# Work Order ID 92606

Item Name: Float Skidtube w/ Full Length Wearplates & Wearpads, LH

Reference: REWORK - ECN12-675 13-534

DRAWING NO. D3887	TITLE A119 STD SKIDTUBE ASSY	REV. B	DART AEROSPACE LTD ENGINEERING ORDER		D.E.O. NO. D3887-B-1	SHEET NO. SHEET 1 OF 1	SCALE NTS
DRAWN AJS	CHECKED <i>q</i>	MFG. APPR. <i>q</i>	APPROVED <i>q</i>		DE APPR. <i>q</i>		
DATE 12.10.29	DATE 12.10.29	DATE 12.10.30	DATE 12.10.30		DATE 12.10.30

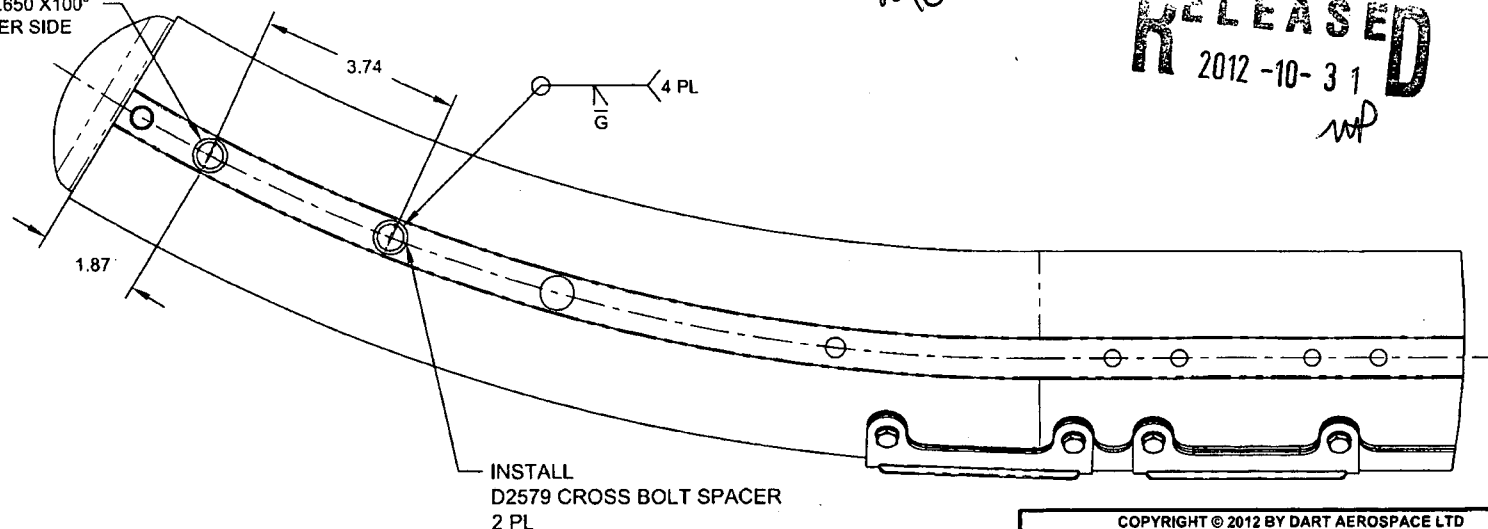
**PURPOSE:**

MODIFICATION OF EXISTING DESIGN TO ALLOW INSTALLATION OF CROSSBOLT SPACERS FOR FORWARD GROUND HANDLING EQUIPMENT.

ADD THE DRILLING DETAIL BELOW TO DRILLING INFORMATION (SHEETS 5 & 6):

ADD CROSSBOLT SPACER INSTALLATION INFORMATION TO -041 THRU -045 (SHEETS 2 - 4):

DRILL Ø0.500 THRU  
CSK Ø0.650 X100°  
2 PL PER SIDE

**FIGURE 1. MODIFIED D119-646-XXX SKIDTUBE**

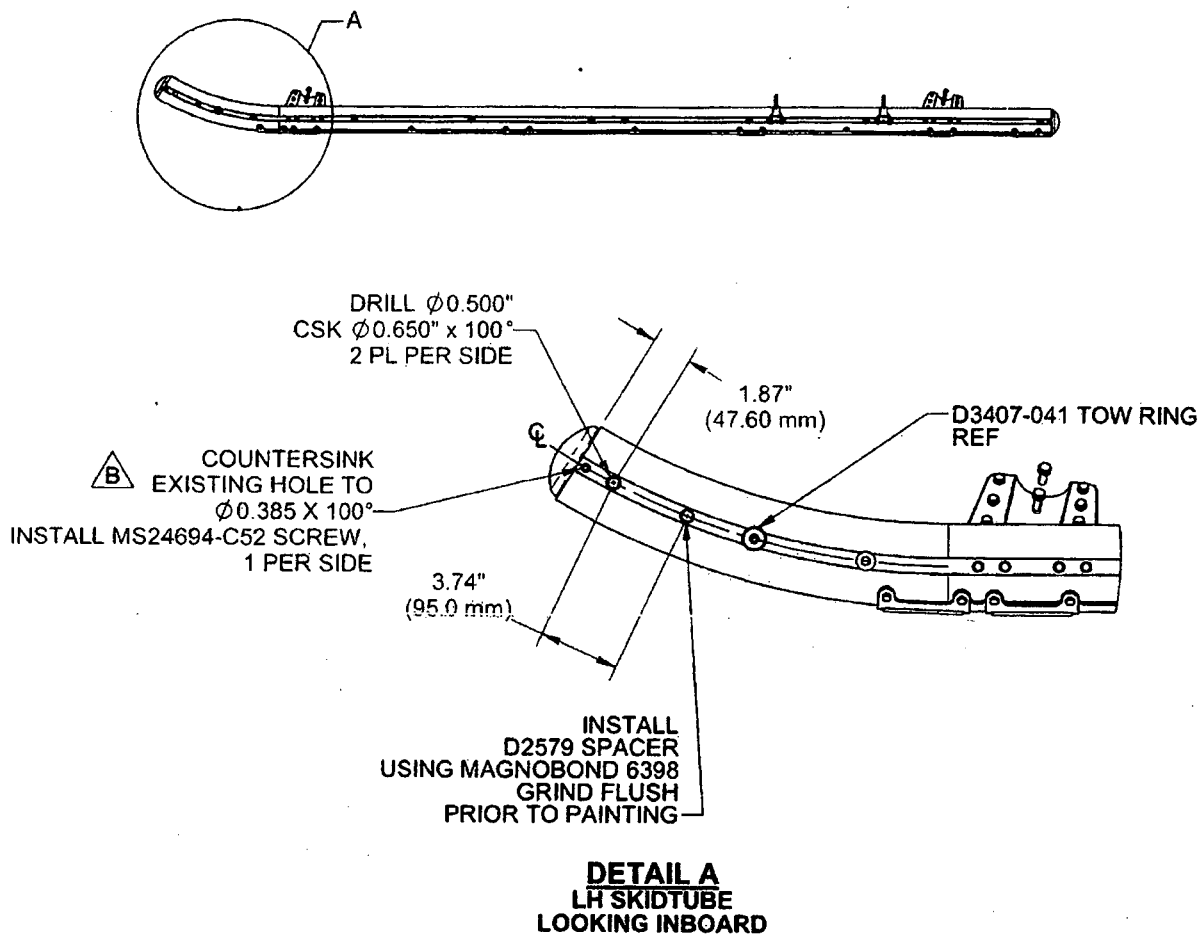
- 2.1 Rotate the D3407-041 Tow Ring to the vertical position as necessary.
- 2.2 Mark holes in the center ridge as shown in Figure 1. Drill through skid tube with  $\varnothing 0.500$ " (12.7 mm drill), and countersunk to  $\varnothing 0.650 \times 100^\circ$ , two places per side.

- 2.3 Remove and discard the hardware retaining the forward Cap. Countersink the existing holes to  $\varnothing 0.385 \times 100^\circ$ .
- 2.4 Deburr holes. Touch up affected areas with chemical film material (Alodine 1200 or 1201) per MIL-C-5541.

- 2.5 Bond D2579 spacers into the  $\varnothing 0.500$  holes center in the skid tube using Magnobond 6398. Grind flush prior painting as shown in Figure 1.

- 2.6 Apply one coat of MIL-P-85582 or MIL-P-2337 primer and 2-3 coats of MIL-C-83285 polyurethane coat to match original finish.
- 2.7 Fasten the forward Cap using MS24694-C52 Screws. Seal threads with Proseal 890. Ensure that screw heads sit below skid tube surface.
